**Amendments to the Drawings:**

**REMARKS**

FIG.2

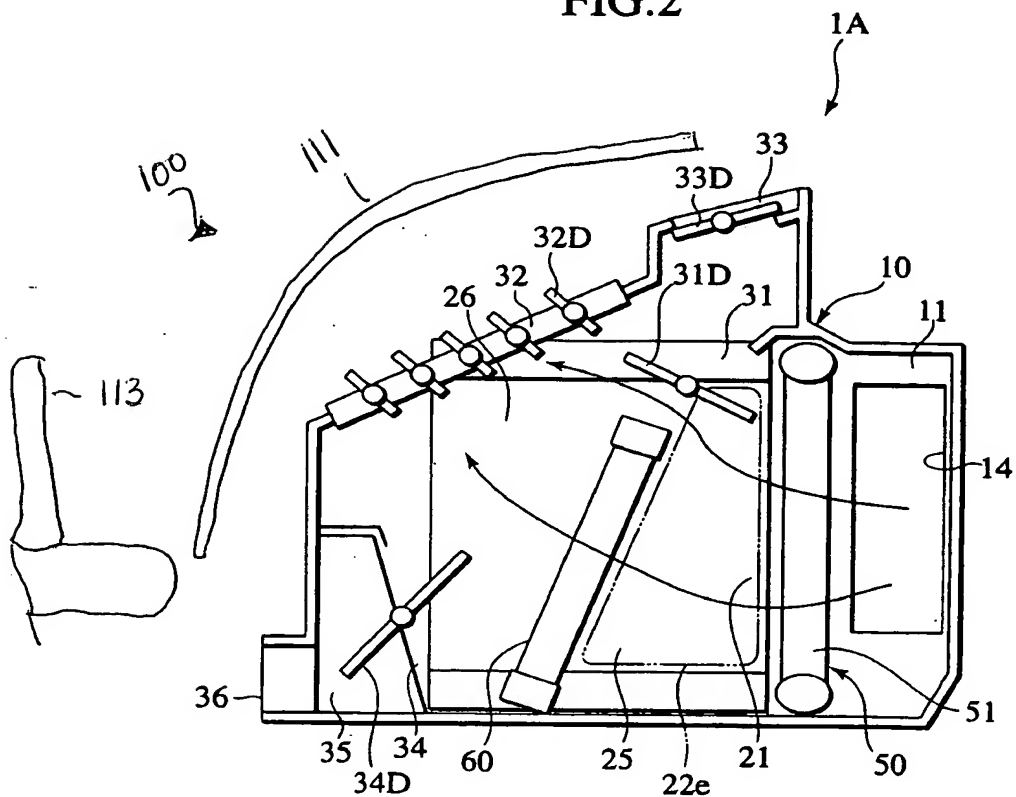
Figures 2 and 3 have been amended to show the air conditioning unit being arranged at a widthwise center of the vehicle 100 in the instrument panel 111 in front of a front seat 113 of the vehicle. Support for the amendments to the drawings can at least be found on page 6, lines 9-14 of the present specification. Thus, no new matter has been added.
